U.S. Department
of Transportation
**Federal Highway
Administration**

Enclosed for your use is the Akard Street and Ervay Street Pedestrian and Bicycle Road Safety Assessment conducted by the Federal Highway Administration with assistance from the North Central Texas Council of Governments and other local partners. The report includes several recommendations for improving pedestrian and bicyclist safety along the Akard and Ervay corridors from Ross Avenue to Elm Street. Thank you for the City’s interest in improving pedestrian safety for the corridor, hosting the assessment, and providing the staff from multiple departments.

Road Safety Audit Akard and Ervay Streets Dallas, TX

Figure 6: Rendering of potential cross-section described above

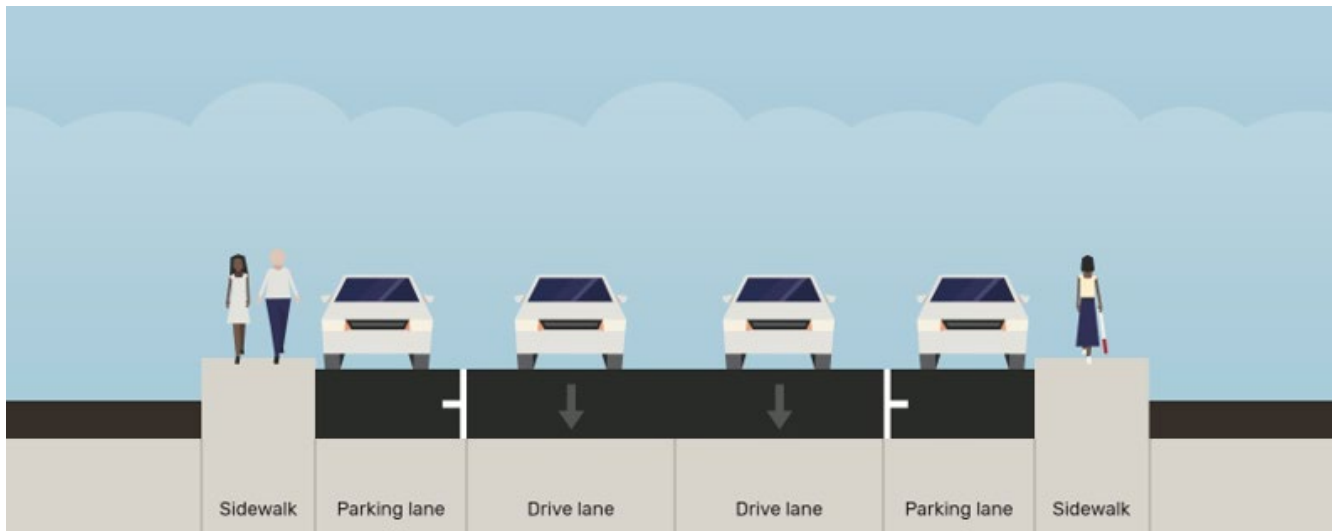
- During our field visits, the RSA Team did not observe capacity issues related to parking utilization. The City could consider changing the Akard cross-section to two through lanes to meet capacity demands. Remaining roadway

width could then be used for other priorities, including wider sidewalks and dedicated parking lanes with possible bulbouts or turn-lanes where appropriate to improve safety and turning operations. Bulbouts extend the sidewalk into the parking lane and reduce the crossing distance for pedestrians. Bulbouts reduce speed of turning vehicles, encourage pedestrians to cross at designated locations, shorten the crossing distance, and prevent vehicles from parking at corners. Bulbouts can also improve sight triangles, which could help locations like Federal Street which has low visibility. The City could consider rideshare curbs near high activity areas where appropriate, similar to existing downtown example on North Harwood Street. Timeline: Medium- to long-term. Where the City decides to continue to allow parking, unambiguous stall pavement markings should be installed per City standard (Standard Construction Details 251D sheet 5011). Timeline: Medium- to long-term.

Figure 8: Rendering of potential improvements for Akard/Erway/Ross

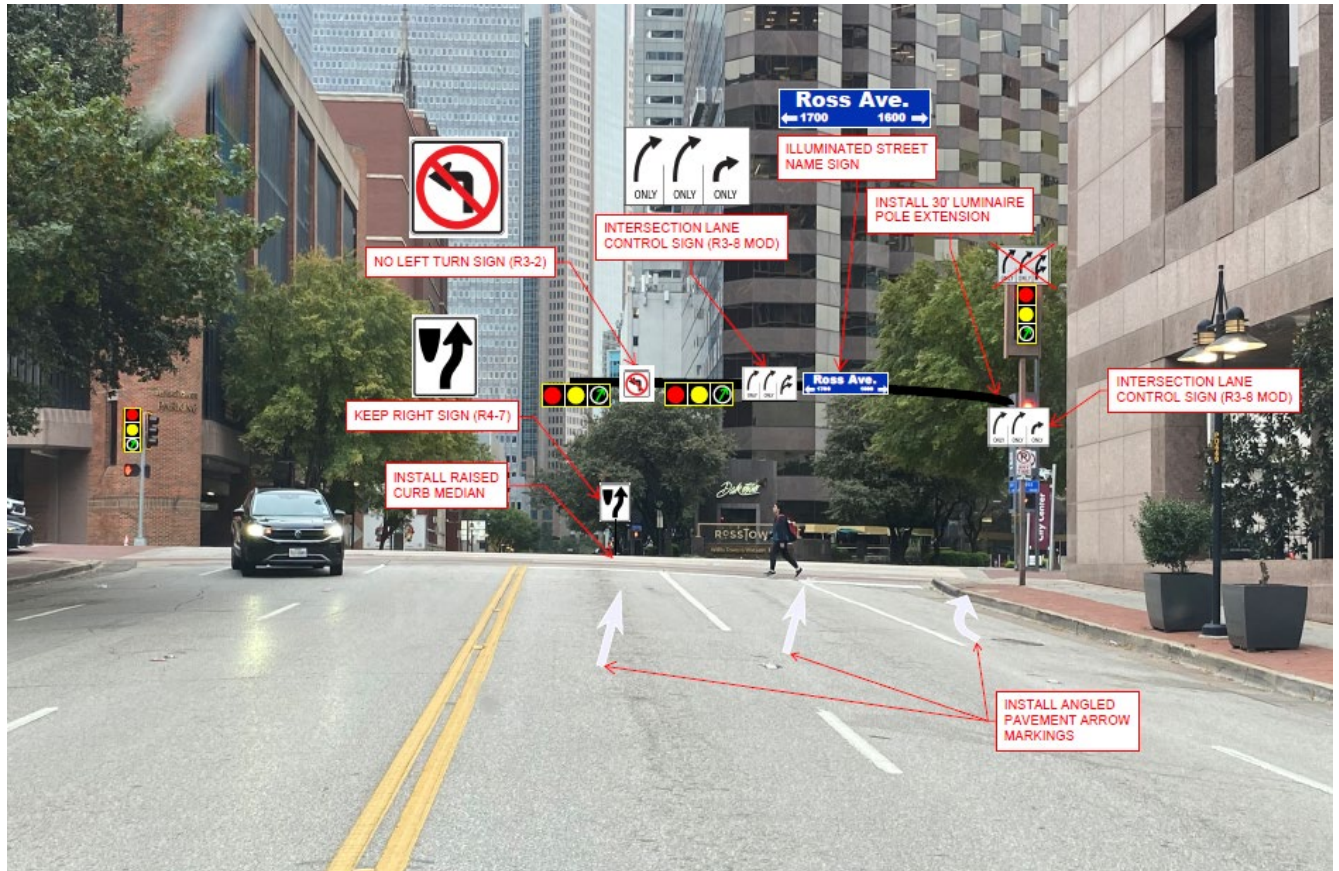
- **Observation:** The RSA Team observed many conflicts between drivers, often due to drivers deviating from their lane assignments as they traveled through the intersection. Drivers often conflicted in the right two lanes south of the intersection where the rightmost lane then allows for parking. The RSA Team also noted a history of right-angle crashes and sideswipe crashes: the last five years of crash data showed 43 crashes at this intersection, 23 of which were right-angle crashes and five of which were sideswipe crashes. The RSA Team observed that for drivers traveling southbound through the intersection, a variety of factors contributed to visibility issues.

Recommendation: Install and/or refresh signage and pavement markings, and consider signal upgrades. Upgrading to the City's current standard of mast arm signals would provide more conspicuous signal head placement and would better accommodate this larger intersection. Green arrow indications in lieu of circular green signal indications would provide more visual guidance to the driver about the upcoming horizontal curve, as would angled arrow pavement markings. Intersection lane control signs, possibly located on mast arms, would be more conspicuous and a supplemental sign on the near side that is located below the signal would reinforce the message. Pavement marking extensions through the intersection (“puppy tracks”) could be installed. South of the intersection, installing a raised curb median for the northbound Erway Street to southbound Akard Street U-turn movement would provide positive guidance and separation for southbound traffic. **Timeline:** Short-term for pavement marking and signage improvements that could be installed in an interim condition, otherwise medium- to long-term.

Figure 11: Pedestrians crossing Akard Street at Federal Street

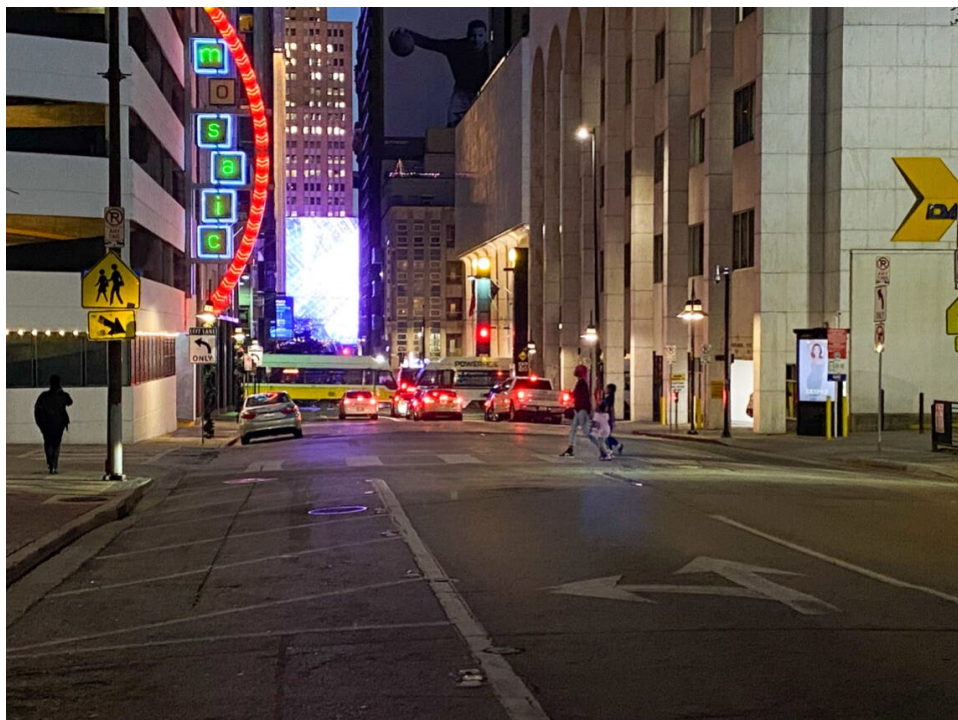
- **Observation:** The RSA Team observed many conflicts between pedestrians crossing Akard Street (using the marked crosswalk or otherwise) and drivers making the eastbound through movement continuing on Federal Street. Due to the skewed configuration, drivers continuing eastbound on Federal Street tended to focus on looking for oncoming vehicular traffic on Akard. This often led to drivers not looking for pedestrians using the marked crosswalk. The RSA Team observed some pedestrians preferring to cross Akard Street north of the existing crosswalk, likely desiring to avoid the conflict with eastbound Federal Street drivers.

Recommendation: The crosswalk could be relocated with enhanced pedestrian improvements, which would remove the conflict with pedestrians crossing Akard Street and drivers making the through eastbound Federal movement. Enhanced pedestrian improvements to the crosswalk could be the addition of a [Pedestrian Hybrid Beacon](#), [Rectangular Rapid Flashing Beacon](#), or [Crosswalk Visibility](#)

Enhancements. **Timeline:** Short-term for pavement markings; medium-term for other enhancements.
